ISSUE: Certificate of Appropriateness for signage

LOCATION: 100-Year-Old Building
3610 Bishop Walker Circle

**BAR#2023-00361**
3610 Bishop Walker Circle

I. APPLICANT'S PROPOSAL

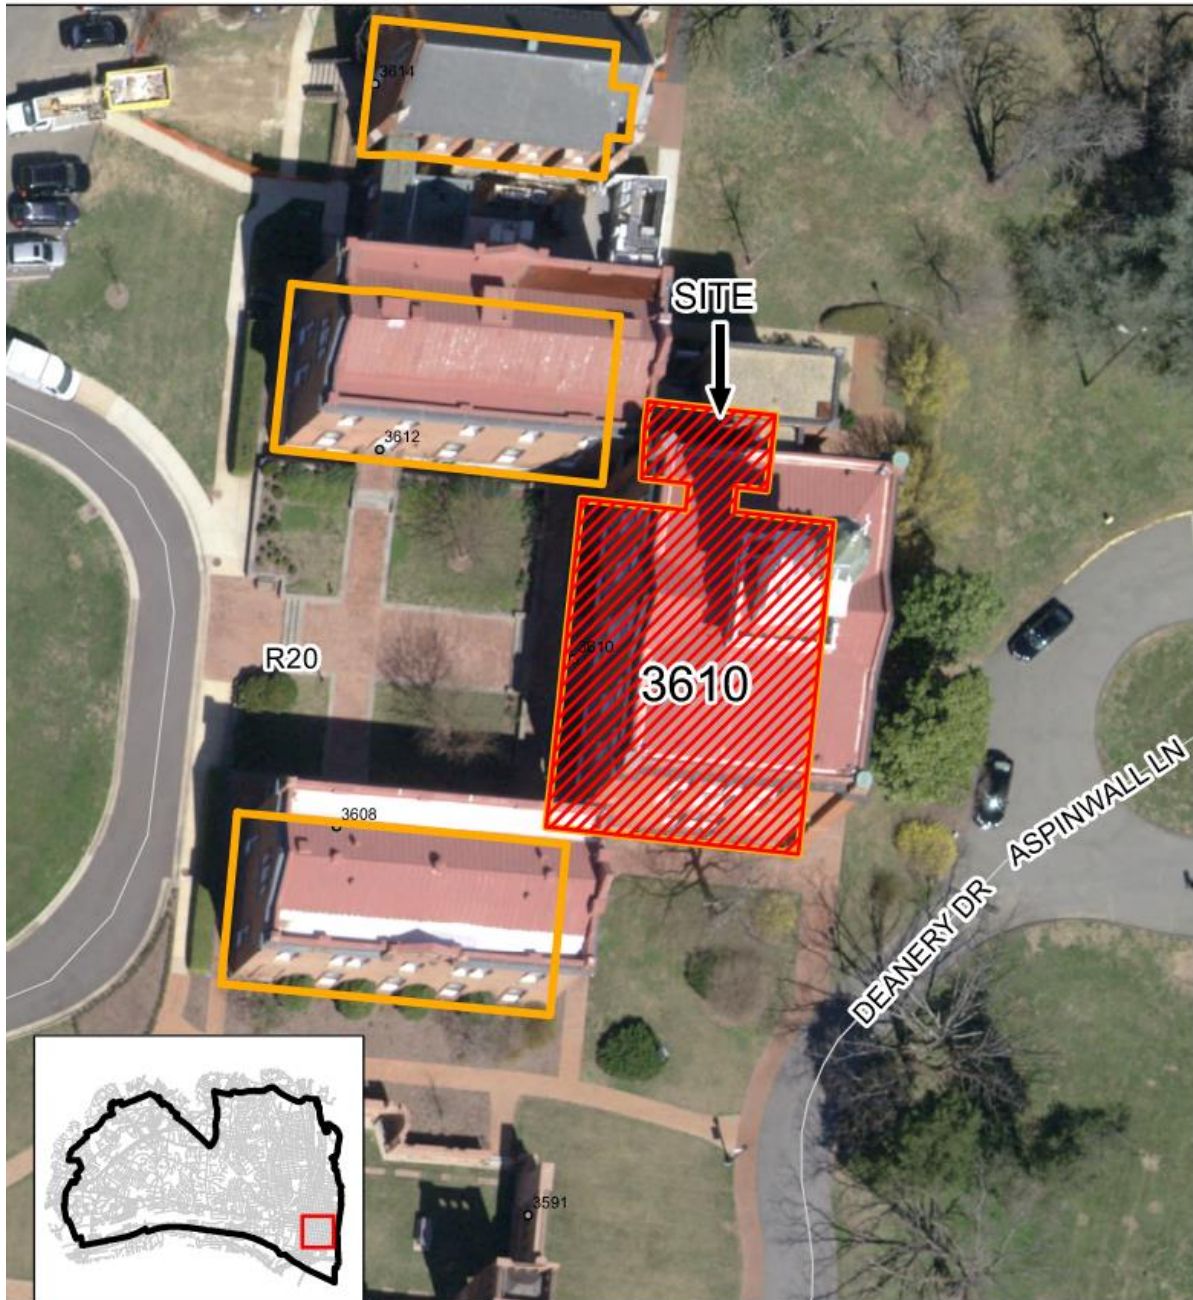
The building sits within the Virginia Theological Seminary complex. The main west elevation faces Bishop Walker Circle, and the secondary main east elevation faces Aspinwall Lane. The proposed louvred panel will be installed on the cupola's northeast side which doesn't face any pathway (Figure 1). The existing hatch to be replaced by a louvred panel is minimally visible from any pathway (Figure 2).

Staff has no objection to the proposed louvred panel to be installed to hide the new exhaust fan inside the building’s cupola. The louvred panel will replace the existing hatch (Figure 3) on the cupola northeast face which is minimally visible from the ground and on the least visible elevation. The proposed louvred panel will be painted to match the building's cupola color. Therefore, staff recommends approval of the Certificate of Appropriateness for alterations as submitted.

Staff recommends approval of the Certificate of Appropriateness as submitted.
